Parks for People  
**Phase 2 Engagement Outcomes Report**  
Carrawood Park, Carramar

April 2021

This Engagement Outcomes Report presents the results from the second phase of consultation that sought community feedback on the Draft Concept Design. The consultation took place between 12 March 2021 and 6 April 2021 and captured the feedback from 31 community members.

Figure 1: Draft Concept Design presented to the community during Phase 2 engagement

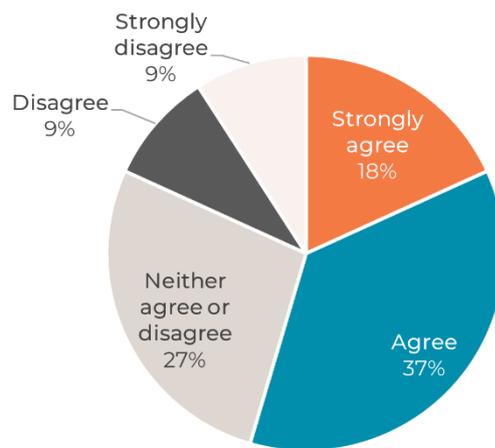
Overall, the majority of participants confirmed that "the design team is on the right track", with only two participants disagreeing with this statement. For those who disagreed, responses were justified by a need to emphasise design considerations, rather than issues with the proposed elements of the draft Concept Design. Broadly, participants appreciated that the design retained natural bush elements while providing inclusive facilities which encourage people to gather, socialise, and get active.

**Dog facilities:** Two survey participants and five Design Board comments highlighted that the Park is currently used by a lot of dog owners, and the draft Concept Design fails to acknowledge a space for dogs or facilities such as drinking bowls or bins. It should be noted that two other survey participants highlighted that they felt the Park was not suitable for an off-leash dog area.

**Safety and antisocial behaviour:** Four survey participants highlighted the need for the final Concept Design to prioritise safety in the Park. While some comments mentioned vandalism and antisocial behaviour in the Park, others simply acknowledged that the Park needed to include design elements that would make users feel safe, and encourage families to return to the Park.

Sufficient lighting, particularly along walkways was acknowledged by all four participants. One community member did raise the need to avoid direct lighting in bush areas, to minimise disturbance for native fauna.

**Inclusive exercise stations:** Three survey participants and two Design Board comments highlighted the need for more inclusive exercise equipment within the Park. Many of these comments noted that the ‘Parkour area’ seemed to cater to a niche part of the community, and would prefer to see exercise areas or stations that catered to a more diverse demographic. Two participants wished to see these facilities integrated along the walking path.
